Project Name / File No.: E Sunnyside PRD / PA22-033  
Applicant: JM1 Holdings, LLC  
Project Description: 28 Lot PRD-Subdivision  
Re: Response to 1<sup>st</sup> Review Comments

This letter serves as the Applicant's formal response to the 1<sup>st</sup> review comments received on October 7<sup>th</sup>, 2022, to our recent application materials submitted to the City of Marysville. To ensure that each of the comments have been responded to, we have incorporated each of the City's comments along with the Applicant's response to each below.

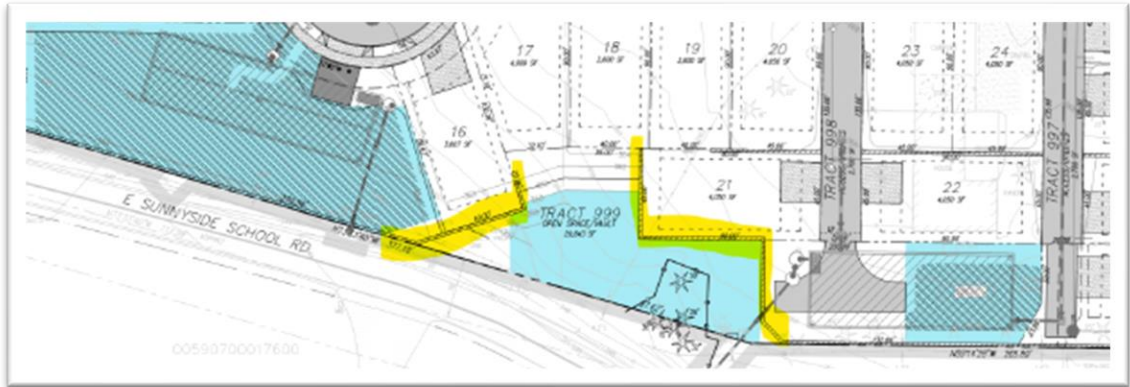
- Based on the below image, the central area of proposed Tract 999 would be blocked off by retaining walls (see highlight). As proposed, this open space tract would not meet the requirements of being accessible and convenient to all residents in the development per MMCG.080.100(4). As proposed, that area would be entirely isolated and inaccessible.

**Applicant's Response: Interior walls have been removed to promote pedestrian circulation.**
